REMARKS

This amendment is provided in response to the Office Action of Nov. 22, 2004. In view of the above amendments, and the following remarks, applicants respectfully request reconsideration of all grounds for objection in this matter.

Amendments to the Drawings:

FIG. 3A

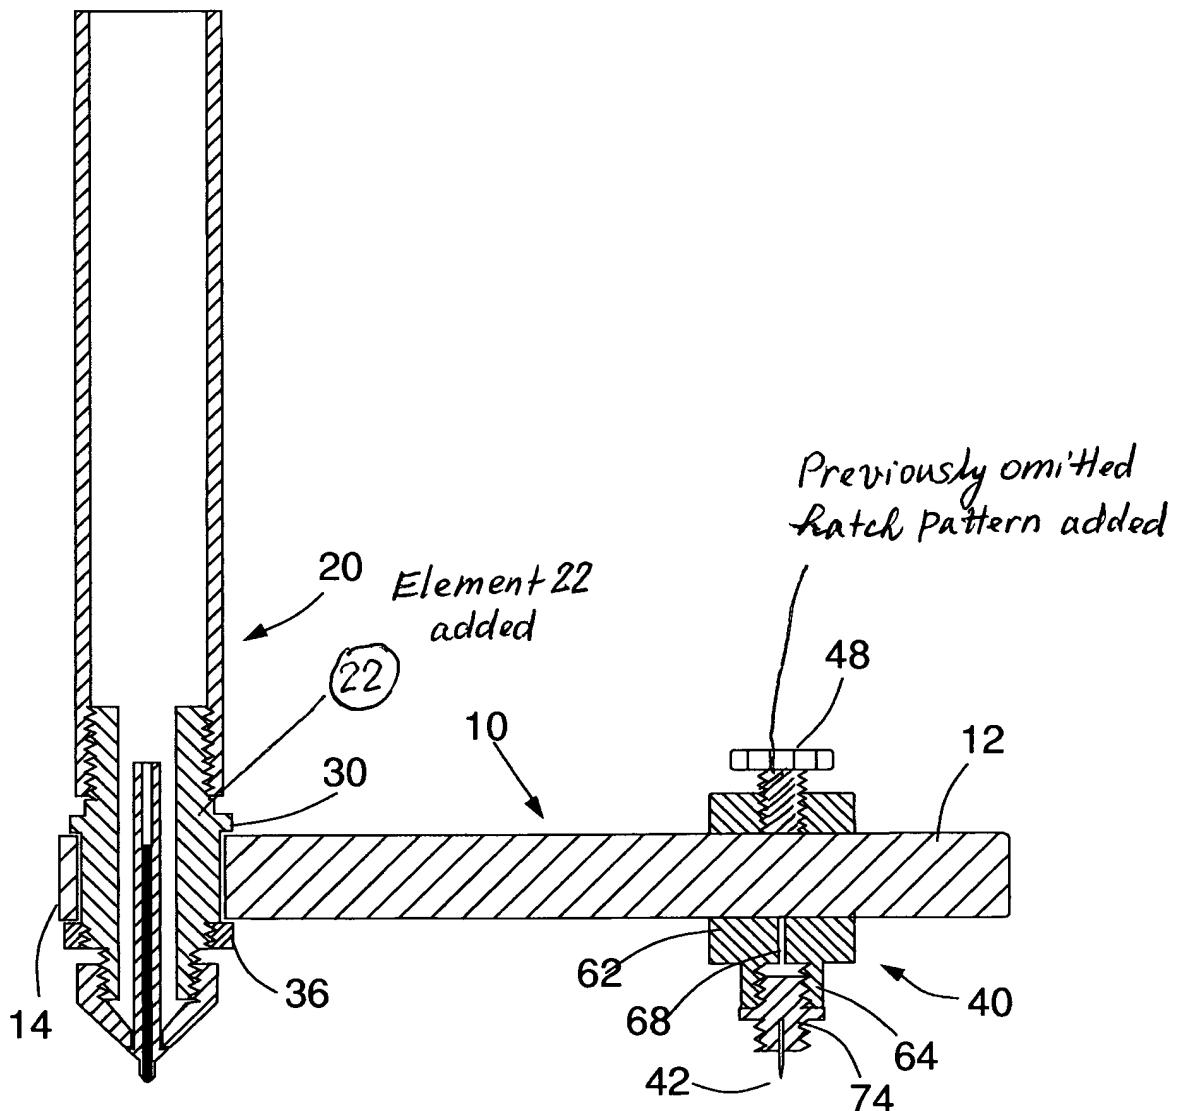
FIG. 3 has been replaced by FIG. 3A where a previously omitted element 22 has been added and a minor error in element 48 has been corrected.

FIG. 3 becomes FIG. 3A.
